To: T10 Technical Committee
From: Tim Symons, PMC-Sierra (Tim_Symons@pmc-sierra.com)
Date: 9 January 2007
Subject: 07-028r0 SAS-2 Address resolved zoning

This is a proposal to remove the address resolved references from the SAS2 draft.

Figure 56 — Example of a ZPSDS with the ZONE ADDRESS RESOLVED bit set to zero

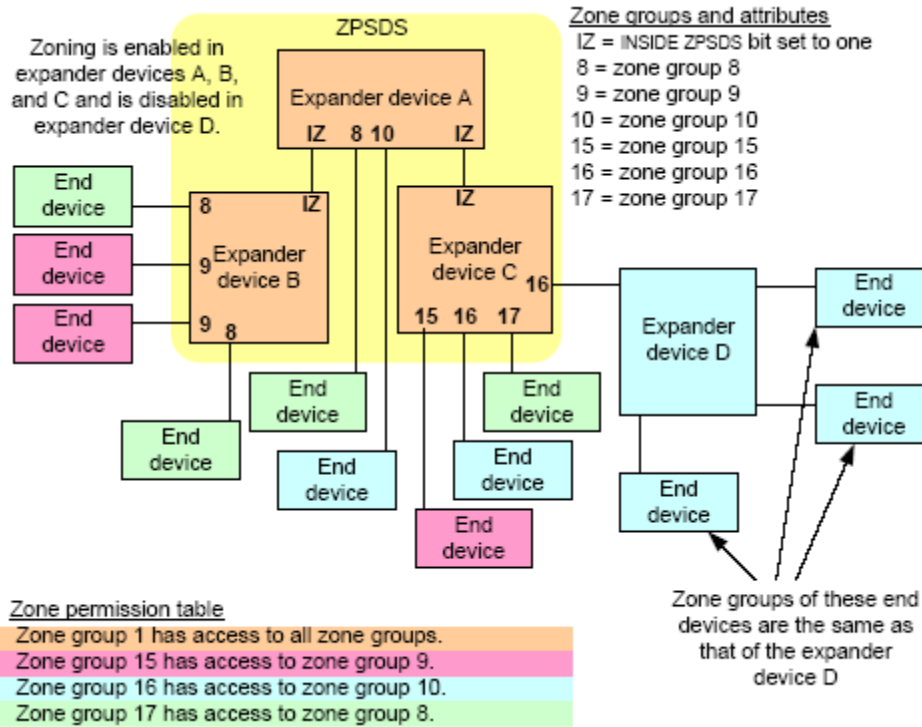
Figure 56 shows an example of a ZPSDS in which the ZONE ADDRESS RESOLVED bit of the expander port of expander device C that is attached to expander device D is set to zero.

~~Figure 57 shows an example of a ZPSDS in which the ZONE ADDRESS RESOLVED bit of the expander port of expander device C that is attached to expander device D is set to one.~~

Editors Note: DELETE FIGURE 57
